**78-90 OLD CANTERBURY ROAD, LEWISHAM  
SECTION 75W – AMENDMENT TO CONDITION B3 (MP08-0195)**

In accordance with Section 75W of the Environmental Planning and Assessment Act 1979 (as amended from time to time), a modification is sought to amend Condition B3 of Concept Approval MP08\_0195. The proposed amendment seeks to reduce the requirement for 50% of the central open space to receive a minimum of 2hrs of direct sunlight during midwinter to 30% as outlined in this submission.

## **Old Canterbury Road, Lewisham Solar Access to Central Open Space**

**Figure 3 Shadow Diagram at 09:45 pm - Plan View**

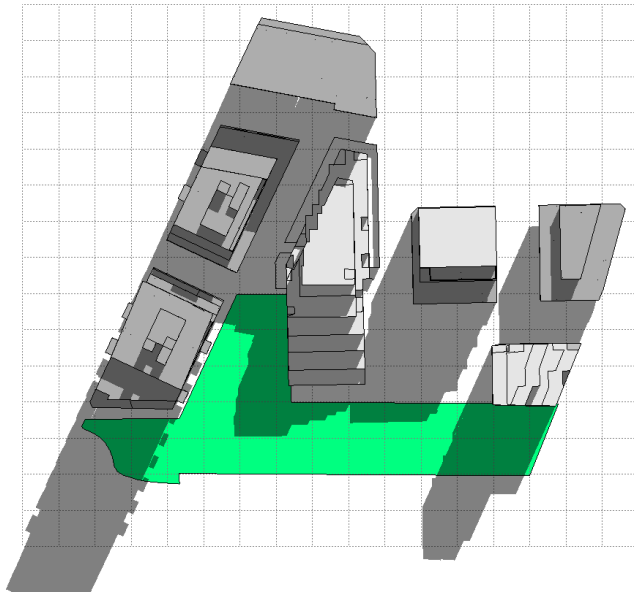
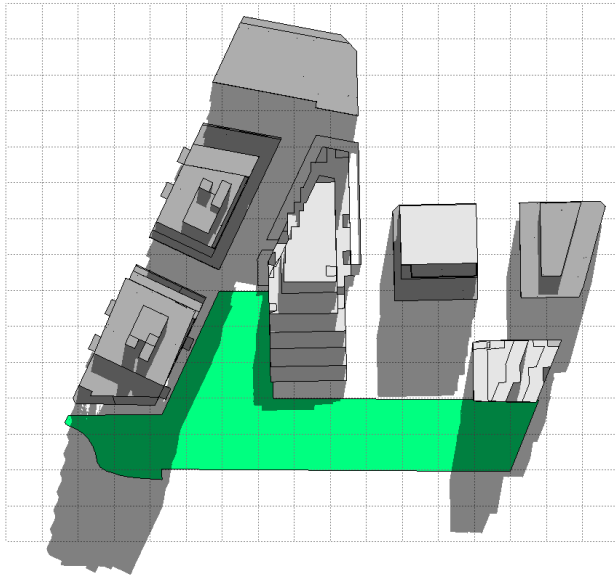
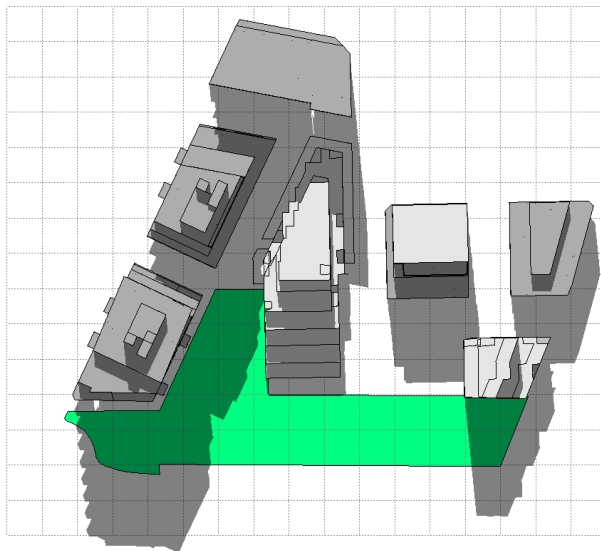
SLR has assessed a number of scenarios to comply with the solar access requirements under the Condition B1. The following modifications to the approved concept floor plans MP08\_0195 are required to achieve 2 hours solar access for 50% of open space on June 21<sup>st</sup>.

- Following changes to Building C
  - Cut 3 m from LG
  - Cut 5.2 m from G and L1
  - Cut 5.0 m from L2
  - Cut 6.5 m from L3
  - Cut 8 m from L4

- Cut 8.5 m from L5
- The stairwell was removed from building E
- Move west façade of Building E by 16 m to the east
- Cut back south façade of top floor (L5) of Building F by 4m

Shadow from the proposed developed were calculated at the best 2 hours of solar access on the 21<sup>st</sup> of June.

<b>Concept Approval which Complies with 50% Solar Access to Open Space</b>		
<b>Time</b>	<b>un-shaded area (m<sup>2</sup>)</b>	<b>%</b>
9:45 am	1491	~50%
10:45 am	1773.3	~59%
11:45 am	1498.3	~50%

**Figure 17: Overshadowing caused by the proposed building envelopes in the Concept Plan (Source: Proponent's PPR)**

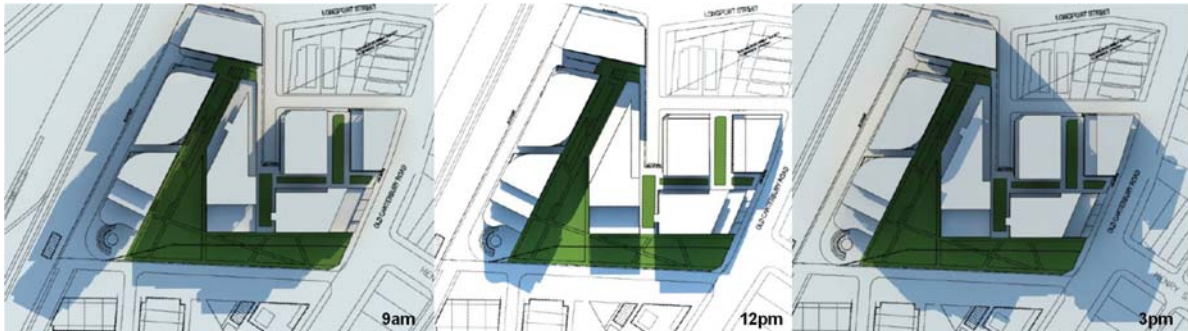
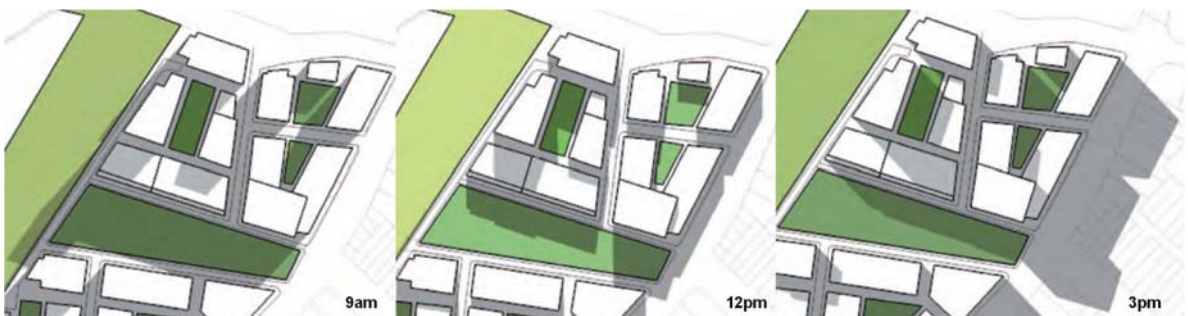
As demonstrated in **Figure 17** and **18**, above, the extent of shadow created by the proposed building envelopes, although greater than the shadows caused by the Masterplan envelopes, will have minimal adverse impacts on surrounding properties to the south of the proposed open space or to the east of Old Canterbury Road. Shadows will be increased to the light rail corridor in the morning, but this area will not be shadowed by the proposal from about 10am onwards.

The main area of increased impact is on the proposed public open space area, which will be significantly overshadowed between 9am and 3pm, midwinter. While the separation between buildings A, C and E allows some sunlight to reach the open space in the middle of the day (primarily between 10am and 1pm), the open space area will be largely overshadowed during the morning and afternoon in mid winter. The shadow diagrams prepared by Hassell (**Figure 18**), however demonstrate that the Masterplan building envelopes will afford increased solar access to the open space.
